System Classification Type: IIg Management Entity: Owner Certified Operator Minimum inspection/maintenance review frequency _____ years.
 Comments: EZ Flow installation
 Installed by: Sammy Gallovey Final Inspection by: Steve R. Ryan RS Date: 7.20.07

File Name: Faye Walker/Eagle Lake Lot 168

Permit No.: 07-151

EZ Flow
drainfield

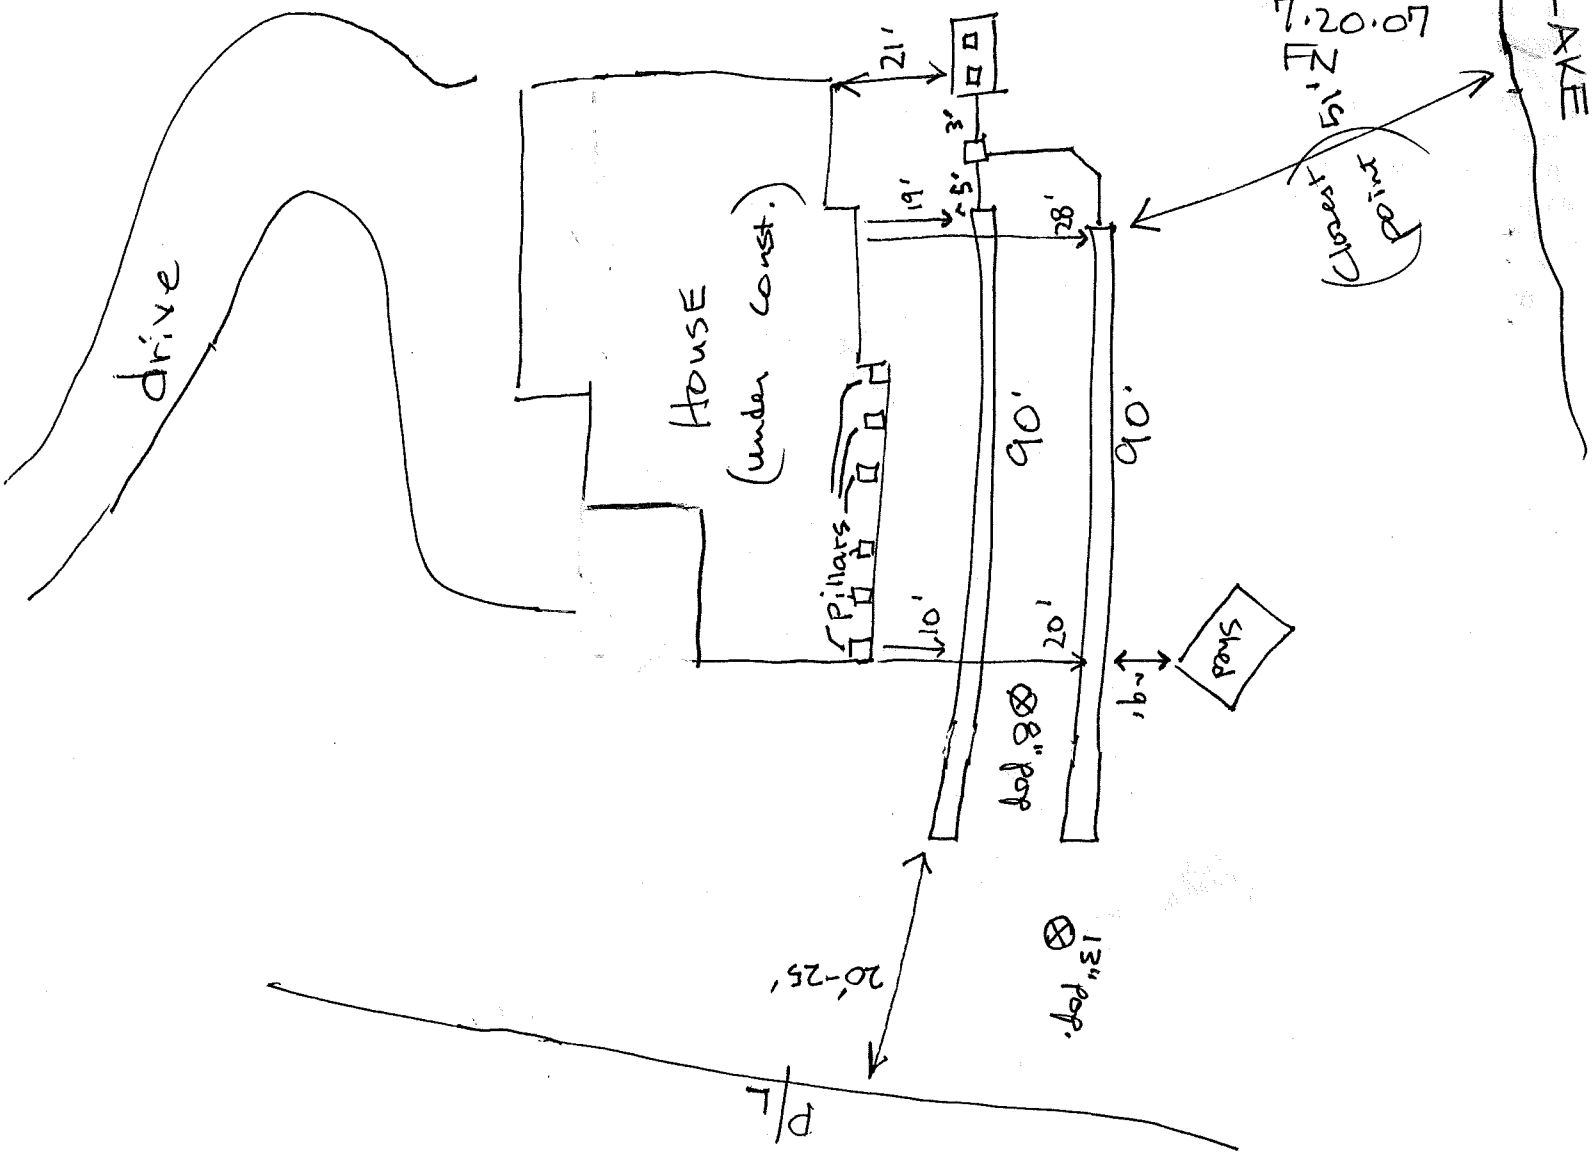
both trenches
at same
grade

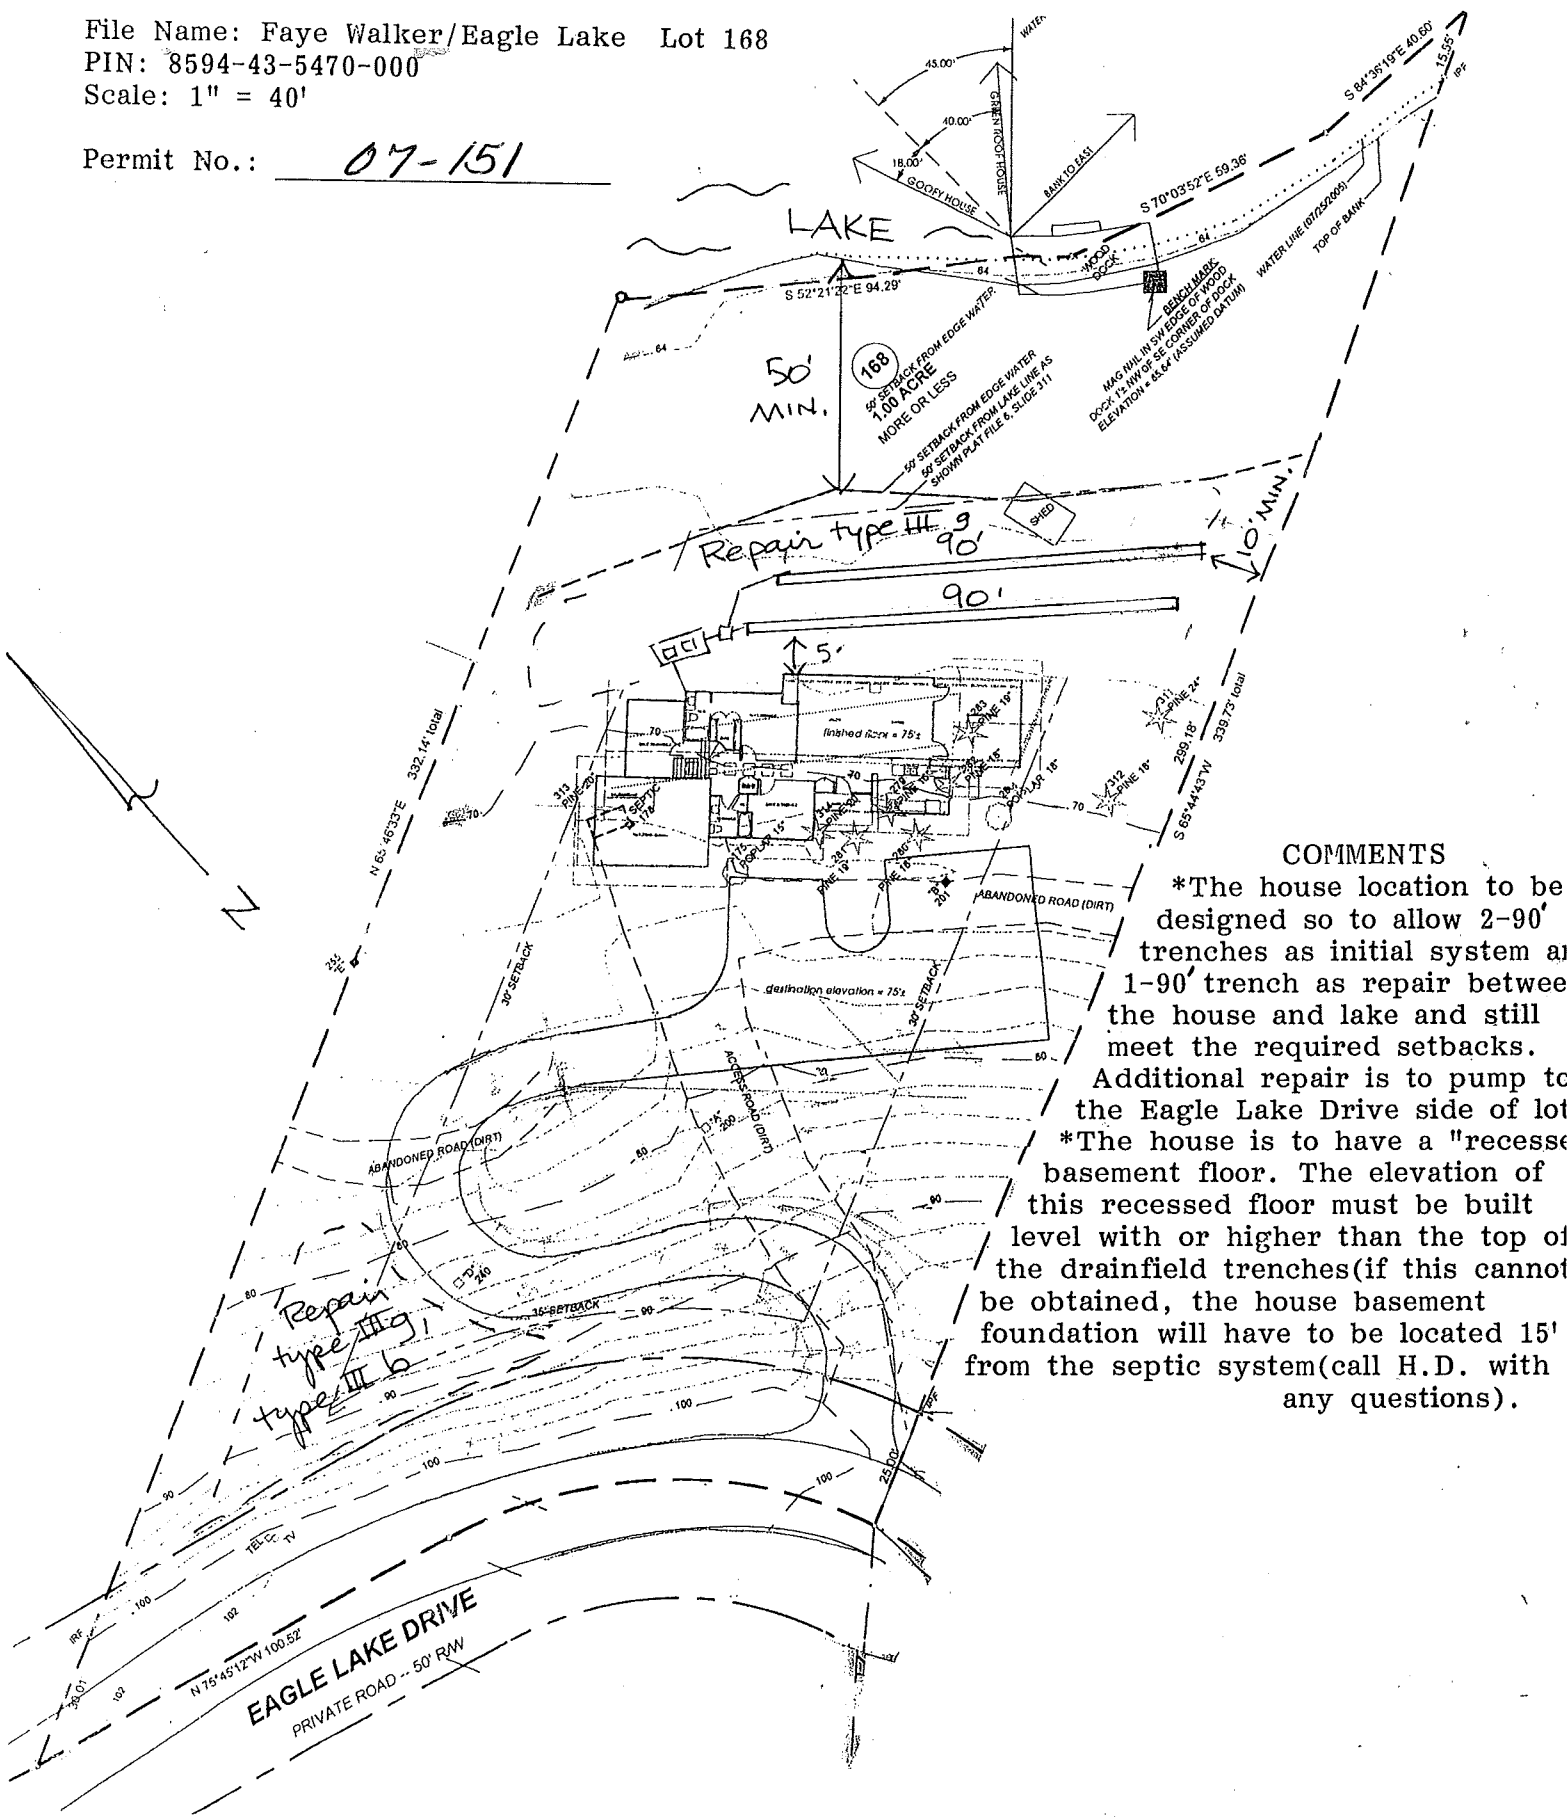
- *The house location to be designed so to allow 2-90' trenches as initial system at 1-90' trench as repair between the house and lake and still meet the required setbacks. Additional repair is to pump to the Eagle Lake Drive side of lot
- *The house is to have a "recessed" basement floor. The elevation of this recessed floor must be built level with or higher than the top of the drainfield trenches (if this cannot be obtained, the house basement foundation will have to be located 15' from the septic system (call H.D. with any questions).
